Rezoning Transportation Analysis

Petition Number: 2019-023

Reviewer: Molly T. Haynes
 Molly.haynes@charlottenc.gov
 704-336-1496

Date	Description
03-05-2019	First Review
05-16-2019	Second Review

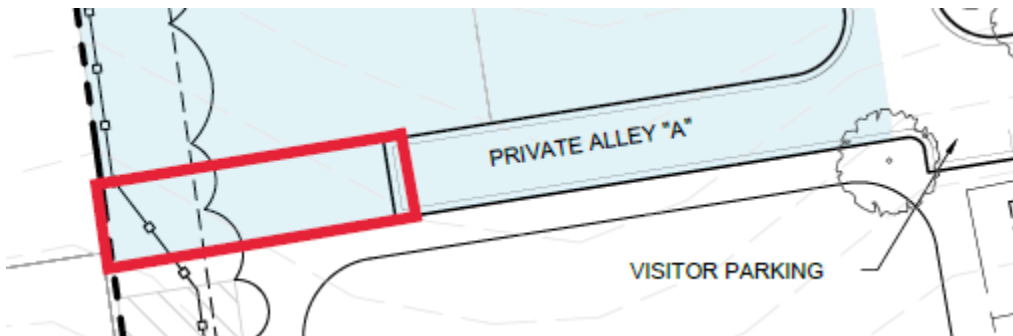
6. The petitioner should extend the proposed 'Private Alley A to the property line as illustrated below.
